RESPONSES TO COMMENTS ON DRAFT ENVIRONMENTAL IMPACT REPORT/ ENVIRONMENTAL IMPACT STATEMENT

Potrero HOPE SF Master Plan

CITY AND COUNTY OF SAN FRANCISCO
PLANNING DEPARTMENT
CASE NO. **2010.0515E**

DATE: October 8, 2015
TO: Members of the Planning Commission and Interested Parties
FROM: Sarah B. Jones, Environmental Review Officer
Re: **Attached Responses to Comments on Draft Environmental Impact Report / Environmental Impact Statement Case No. 2010.0515E: [Potrero HOPE SF Master Plan Project]**

POTRERO HOPE SF MASTER PLAN (CASE NO. 2010.0515E)
FIGURE 4.3-1: VIEWPOINTS LOCATION MAP

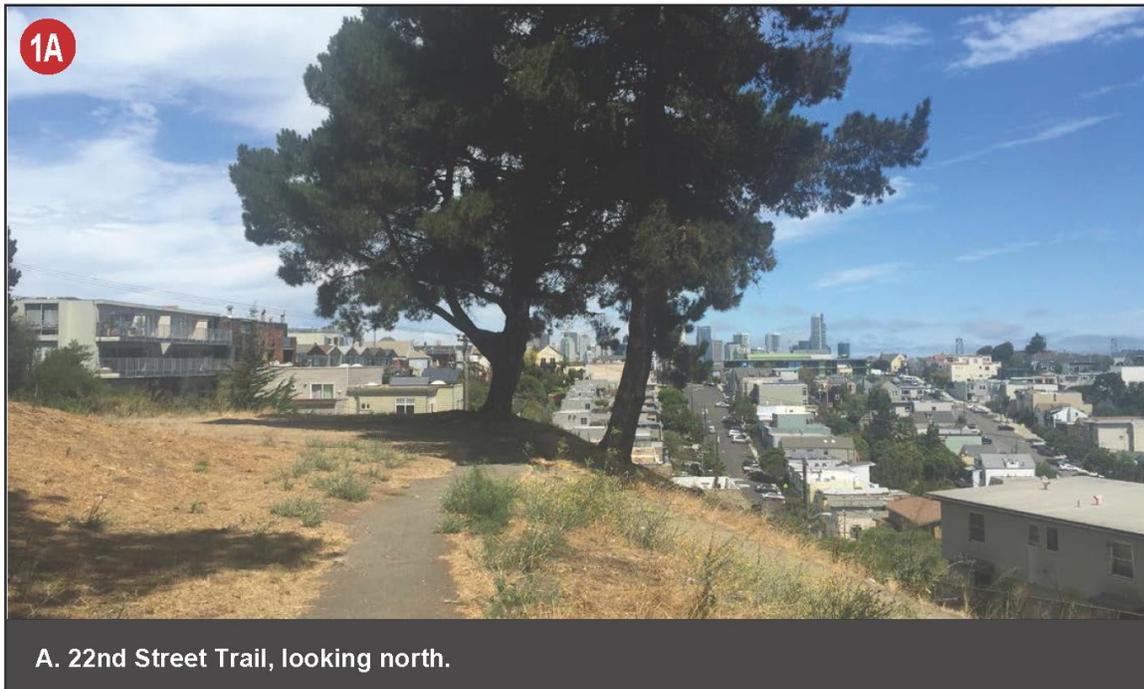
viewer locations, which include parks, publicly accessible buildings, and sidewalks that offer a view of the urban and natural landscape making up a viewshed. Since the preparation of the Draft EIR, additional views from these vantage points have been added to the analysis, including from the eastern terminus of the 22nd Street Trail, the bench below the tennis courts, and the Potrero Hill Recreation Center. The views from each of these nine vantage points are depicted on Figure 4.3-1 and Table 4.3-1 of the revised analysis.

Potrero Hill Recreation Center. The views from each of these nine vantage points are depicted on Figure 4.3-1 and Table 4.3-1 of the revised analysis. The existing views are depicted in Figure 4.3-2 through Figure 4.3-10 of the revised analysis. Viewpoints 1A through 1C represent views from the eastern terminus of the 22nd Street Trail and the bench below the tennis courts. Viewpoints 2A through 2C represent views from a scenic vista, in this case, looking south from the Recreation Center playfields. Viewpoints 2D through 2F show views looking east from the Recreation Center playfields. Viewpoints 3 through 7 represent public views of and through the Project site from outside the Project site. For the purposes of the NEPA analysis, a view of scenic resources is defined as a public view that is broad and expansive and of a significant landscape feature or of a significant historic or architectural feature. In the vicinity of the Project Site, the views from portions of Recreation Center and the 22nd Street Trail are considered scenic with high viewer sensitivity due to the nature of the use and the views of the Bay, East Bay Hills, San Francisco downtown, San Bruno Mountain, and McLaren Ridge from certain public areas of the park.

POTRERO HOPE SF MASTER PLAN (CASE NO. 2010.0515E)
FIGURE 5.3-2: PROPOSED PROJECT, 22ND STREET TRAIL, LOOKING SOUTHEAST (VIEWPOINT 1B)

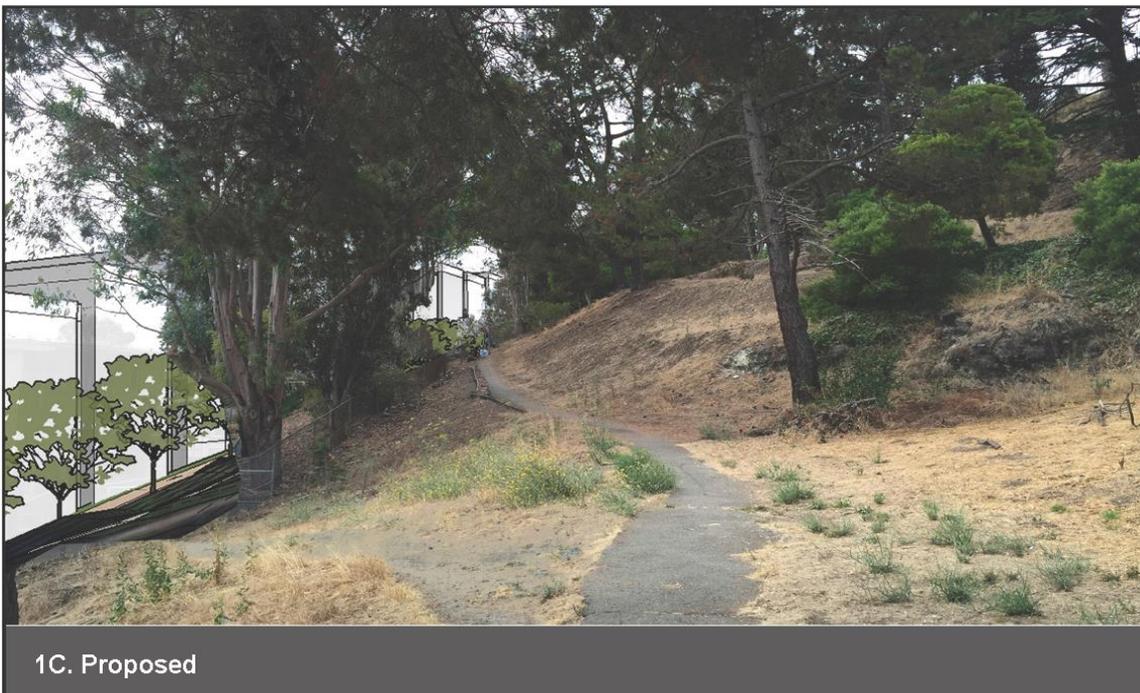
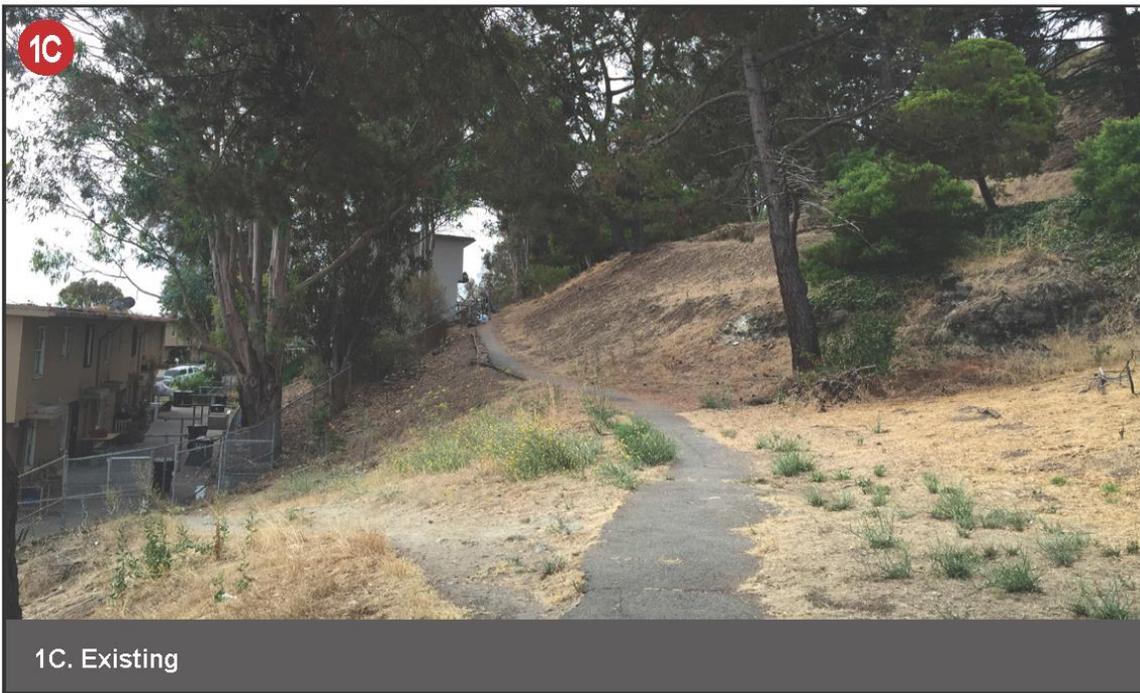
The views from the eastern terminus of the 22nd Street Trail and the bench below the tennis courts are depicted in Figures 5.3-1 through 5.3-4 (Viewpoint 1A through 1D) and analyzed under Impact AE-1 of the revised analysis. As discussed, views looking northeast and southeast afford a nearly panoramic view of the San Francisco downtown area, the Bay Bridge, the Bay, and the East Bay Hills and viewer sensitivity is considered high from this location. As shown in Figure 5.3-1 and 5.3-2, the Project would not substantially obstruct these views and changes to the viewshed from the eastern terminus of the 22nd Street Trail are considered less than significant. As shown in Figure 5.3-3, which illustrates the view looking south from the 22nd Street Trail, the Project would not introduce elements into a currently unobstructed view. Finally, the view from the bench below the tennis courts, as shown in Figure 5.3-4 would not be affected by the Project due to the vegetative screening and because development is a common visual element in this view.

As shown in Figure 5.3-3, Viewpoint 1C, the proposed building at Block O would be visible from the 22nd Street Trail looking south along the eastern edge of the Recreation Center. Block O would be taller and be slightly larger in mass and bulk than the existing buildings on-site. But the building at Block O would not introduce elements into a currently unobstructed view. Existing views looking south are mostly limited to the foreground by existing residential development located on the Project site and dense vegetation along the edges of the trail. Middleground and background views of the Bay and the East Bay Hills beyond, are not available looking in this direction. Foreground, middleground, and background views would be similar under the Proposed Project.

As shown in Figure 5.3-4, Viewpoint 1D, the existing development at Potrero Annex is not readily visible in views looking east from the bench below the tennis courts. While the proposed Building Block R would be visible, because it would taller than the existing buildings at that location, middleground and background views of the surrounding Bay and East Bay Hills would remain the focal point. These views are available through gaps in the hillside vegetation, and these views would be maintained under the Project, even with the taller buildings. In addition, the proposed buildings would not stand out in this view because of the vegetative screening and because development is a common visual element in this view.

POTRERO HOPE SF MASTER PLAN (CASE NO. 2010.0515E)
FIGURE 5.3-7: PROPOSED PROJECT, POTRERO HILL RECREATION CENTER, LOOKING SOUTH (VIEWPOINT 2C)

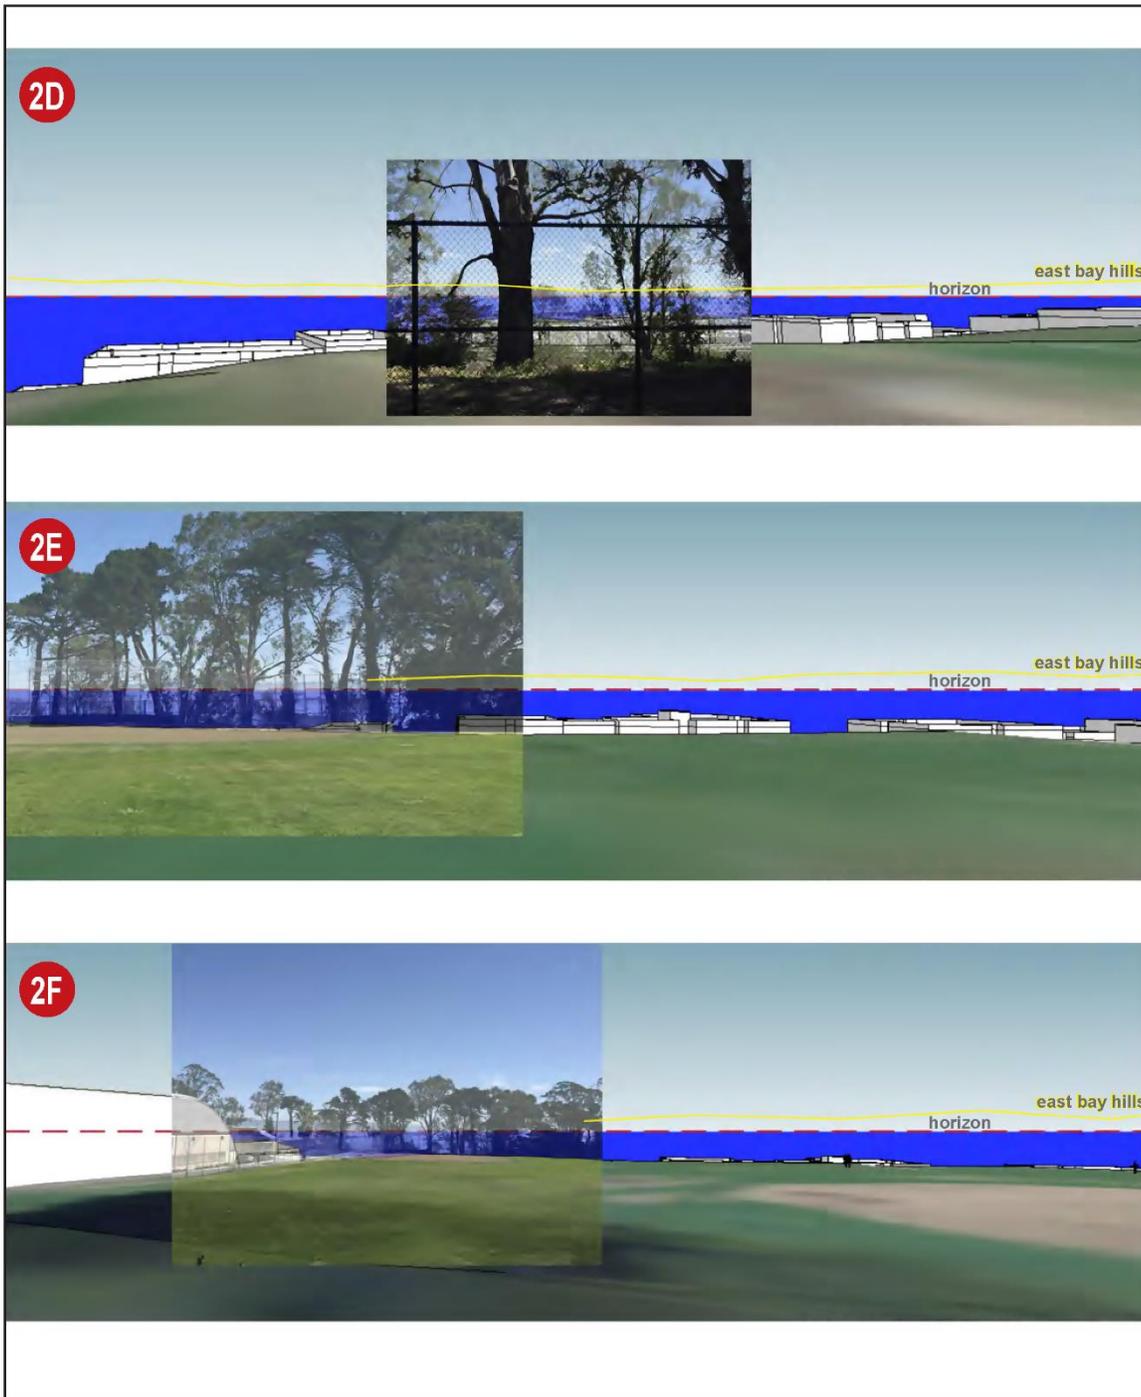
As shown in Figure 5.3-8 of the revised analysis, views looking east from the Potrero Hill Recreation Center playfields would not be affected by the Project due to the steep slopes adjacent to the park. Furthermore, these views are dominated by existing dense vegetation that obscures views to the east. The vegetation would remain following Project implementation.

POTRERO HOPE SF MASTER PLAN (CASE NO. 2010.0515E)
FIGURE 5.3-18: REDUCED DEVELOPMENT ALTERNATIVE, CONNECTICUT STREET AT CESAR CHAVEZ STREET,
LOOKING NORTH (VIEWPOINT 8)

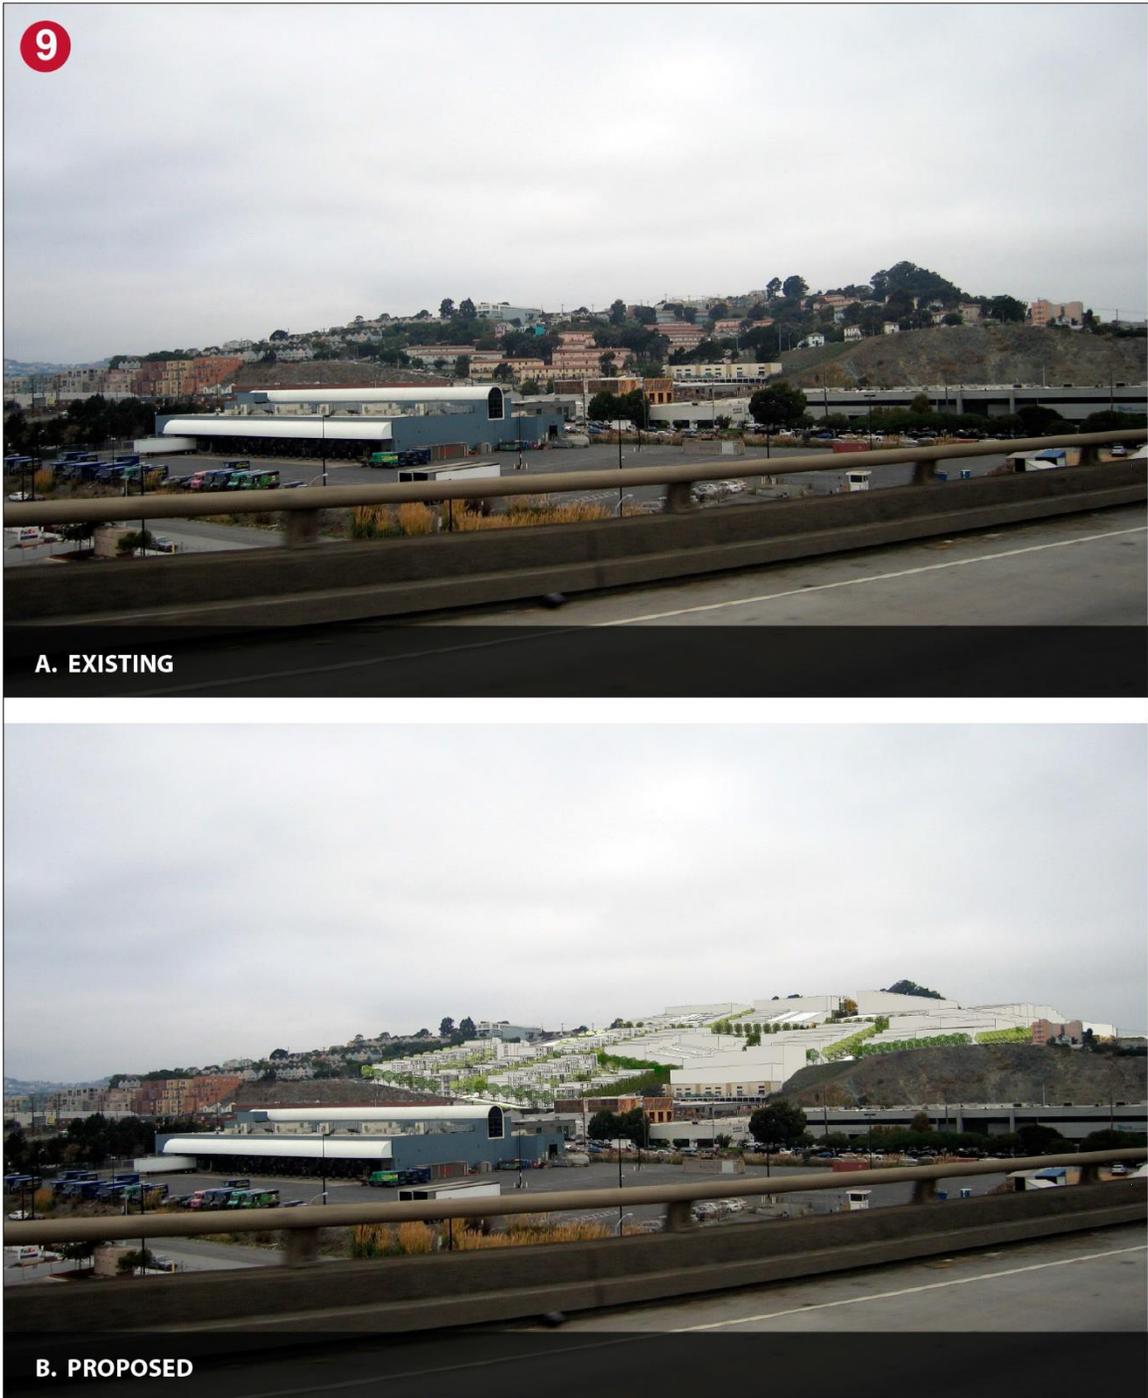
Figure 5.3-15 of the revised analysis illustrates the Reduced Development Alternative from I-280. The commenter is correct that part of the Project site (the west side) does not look well articulated when compared to the east side of the site. The boxy forms shown in the eastern portion of the Project are presented to only to illustrate the general massing that is proposed. Upon buildout of the Project, it is anticipated that the articulation would be similar to what is shown in the western side of the site in this figure.

Intersection of Cesar Chavez Street and Connecticut Street (Viewpoint 8). As shown in Figure 5.3-12-18 Photo A, foreground views from the intersection of Cesar Chavez Street and Connecticut Street include light industrial and warehouse buildings and some of the existing structures at the Project site. Figure 5.3-12-18 Photo B represents the view from this location with implementation of Alternative 1. Channelized views of distant hills are seen. With implementation of Alternative 1, new housing would be added to the west of Wisconsin Street at a height of up to 40 feet. These multi-family buildings would be similar in height and compatible in massing with the existing single-family residential development in the area. A substantial portion of the existing channelized background view would be retained, and no other major views would be obscured from this location.
